DEPARTMENT OF PLANNING AND PERMITTING
CITY AND COUNTY OF HONOLULU

Shoreline Setback Variance 2004/SV-13
Final Environmental Assessment (Final EA)

Owner/
Applicant : Michael J. Ells
Agent : Analytical Planning Consultants
Location : 68-001 Laau Paina Place, Waialua
Tax Map Key : 6-8-009: 10
Request : Shoreline Setback Variance
Proposal : To retain an existing CRM seawall within the
40-foot shoreline setback area.

**FINAL ENVIRONMENTAL ASSESSMENT FOR A
SHORELINE SETBACK VARIANCE APPLICATION**

CROSS SECTION OF EXISTING SEAWALL
 68-001 Laau Paina Place, Waialua, Oahu, Hawaii

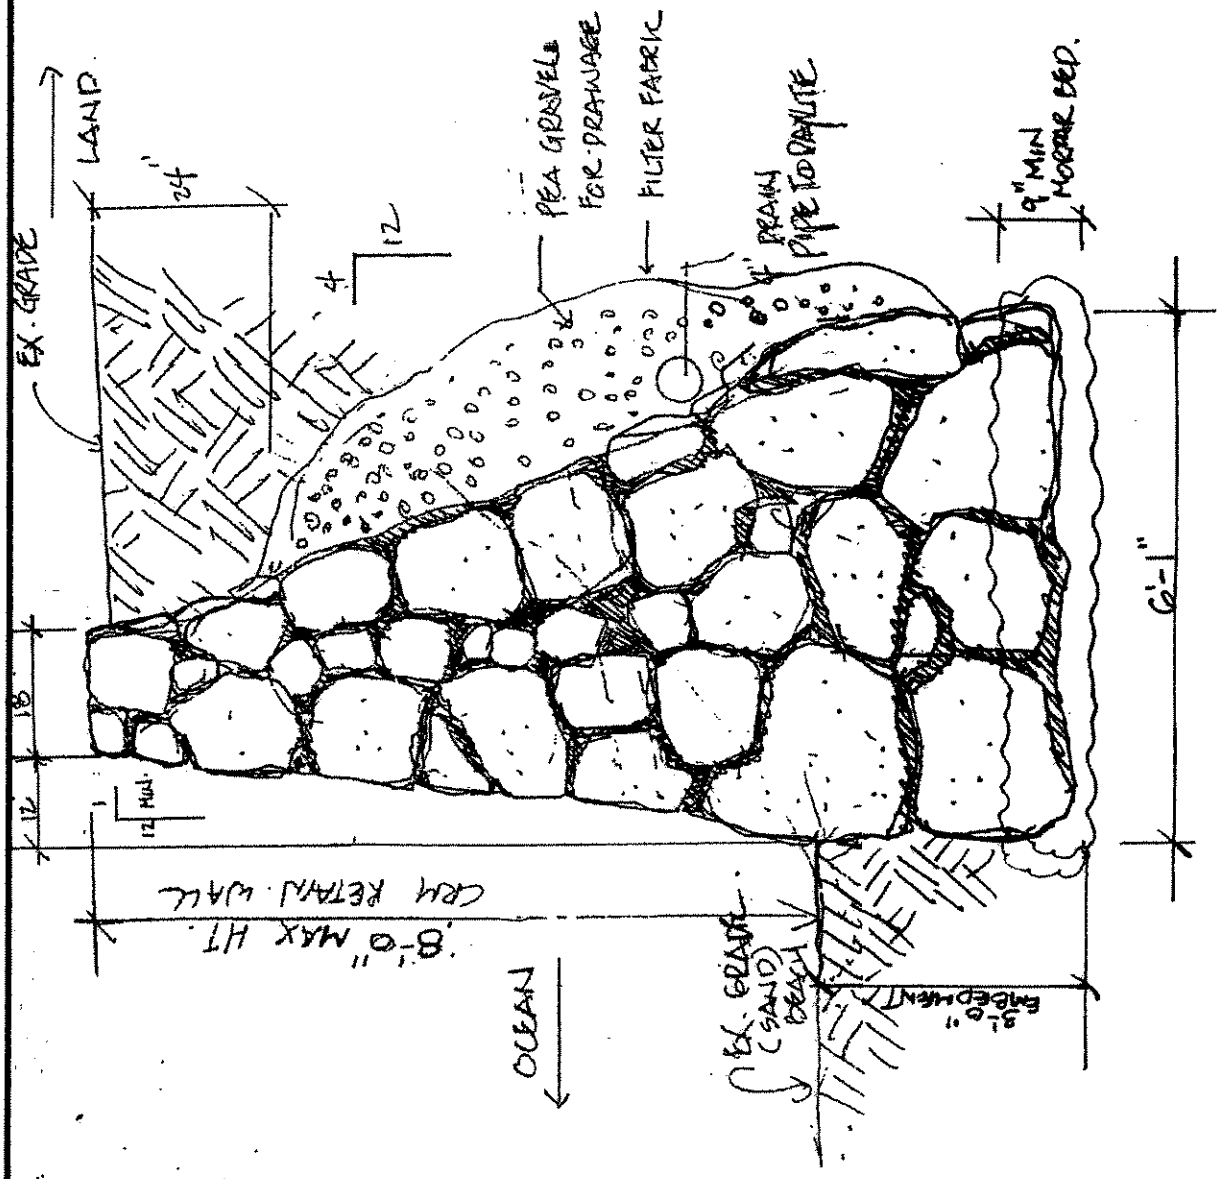
1. The Final EA should include a cross section plan which is drawn to scale. (The base of the plan provided is not to scale and the width, which is labeled "6'-1", only measures 5 1/2 feet.) Photos taken during a staff site visit and the submitted shoreline survey seem to indicate that there are five stairs to the beach. The cross-section of the stairs indicates there are only four stairs. Please verify the number of stairs and revise the stair cross section if needed.

1. The Final EA includes a cross-section plan drawn to scale. Drawings that are not to scale are now clearly labeled "not to scale". Also, drawings now include a bar scale so reduction and enlargement of the drawing are not a factor.

The cross section of the stairs has been corrected to show the existing conditions that five (5) stairs exist.
